Re: Request for a Special Permit Additional Information; 20 Walnut Street, Newburyport, MA (the "Property"); Assessor's Map: 60 Lot 28

## EXISTING HOUSE RENDERING

RICK & SEIKO MORSE 20 WALNUT STREET NEWBURYPORT, M.A. 01950

# EXISTING HOME REAR IMAGES

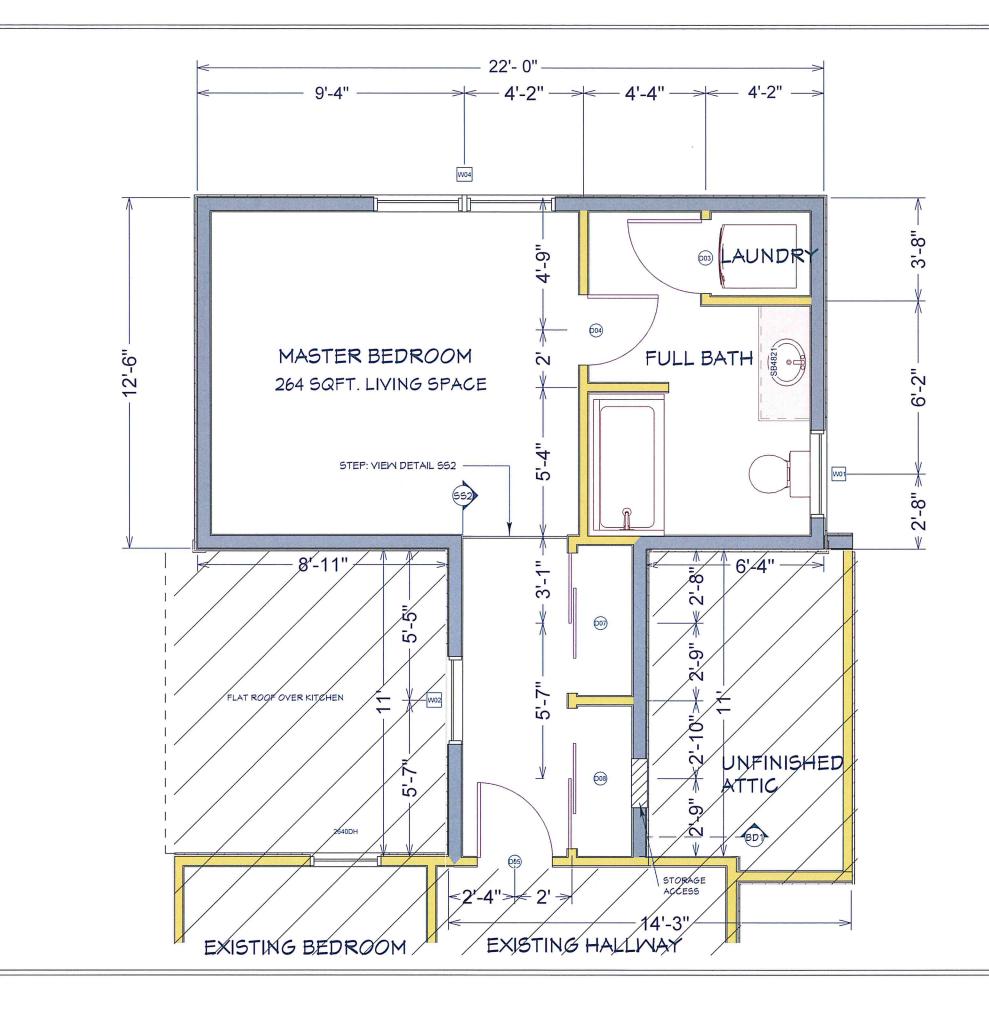
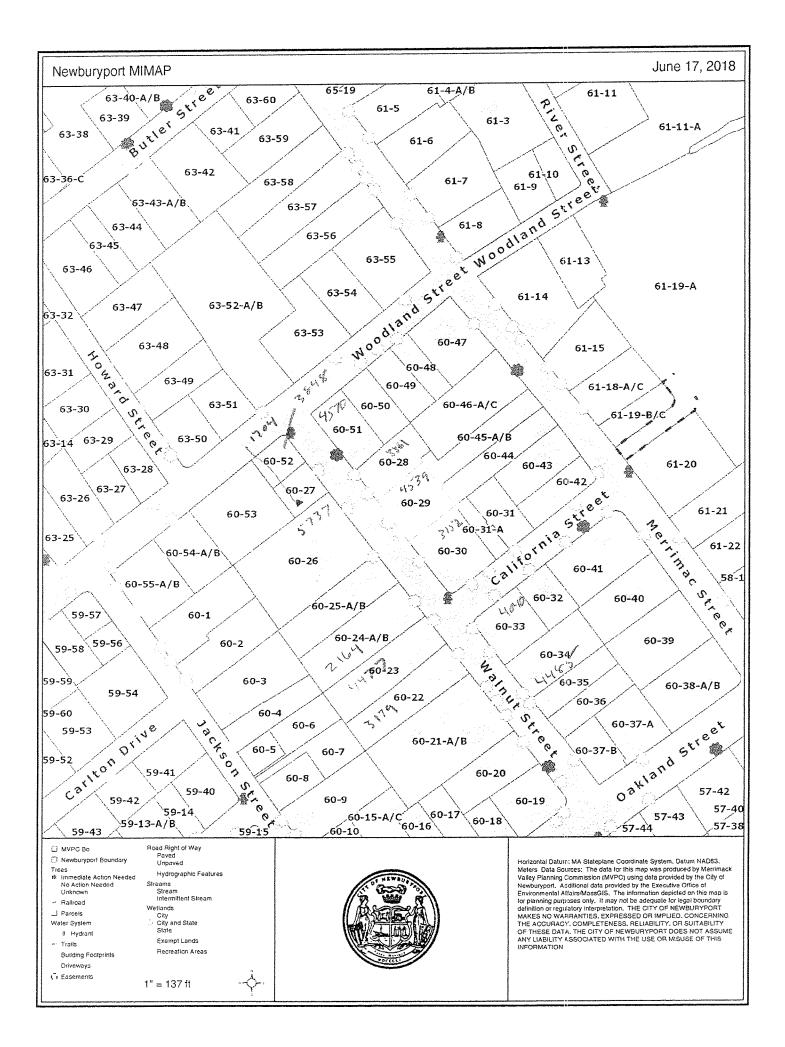
- Height of the addition [allowed by code] does not align with the existing building ridge line. It seems out of place with the character of existing structure. No other additions in the neighborhood rise above their existing roofs. The "massing" of the addition creates some challenges to reduce the visual impact and size of the structure. See below for suggestions.

- 2. Fenestration. The drawings present a "blank" wall as our view. John indicated that considerations of interior requirements have been their main focus, but understood our concern. We would like to see at least one window per floor. Several options were discussed (including two windows per floor and a "faux" blank window at the new stair). We think that one window per floor is a good solution; they do not have to align vertically located as best suits the interior needs.

- 3. Roof lines and massing of addition. In our discussion we all agreed to continue the existing eave line across the addition; the gable end will be built a minimum of 1'0" on the rear elevation. This gives the impression of a separate "dormer". Visually this breaks up the mass and scale of the addition.

- 4. "Connector dormer". Discussed the incompatible appearance of the "pop up" dormer. Suggest shifting interior corridor to align with center line of existing structure; eliminate the pop up dormer and fill in with new roof that aligns with existing. This would have minimal impact on interior space. And improve the visual appearance. John agreed to the change. If there are construction limitations he would get back to us, but did not thing there would be. This solution would be less costly than the dormer.

- 5. Our main concern is that the current design of the addition looks incongruous, out of place, with the surrounding neighborhood, and even the existing dwelling. Suggest lowering the addition ridge line to match existing roof. This combined with the connector roof alignment would reduce the massing and scale of the addition. John raised a concern with lowering the pitch of the addition roof. Currently at 5:12. What is the minimum allowable pitch by code? Would a 3:12 work? Suggest two options: Change the slope (lower) of new roof "dormer" to accommodate the interior of the structure (ie. not change the head room). A membrane roof would be acceptable to us under this condition. (Note: our house has a membrane roof that our neighbors look at.) Or, maintain the 5:12 pitch so the eave would be slightly lower than shown on the drawing elevations. On the interior, the ceiling would not reduce the floor area and have minimal impact on the interior head room and actually add "character" to the space.
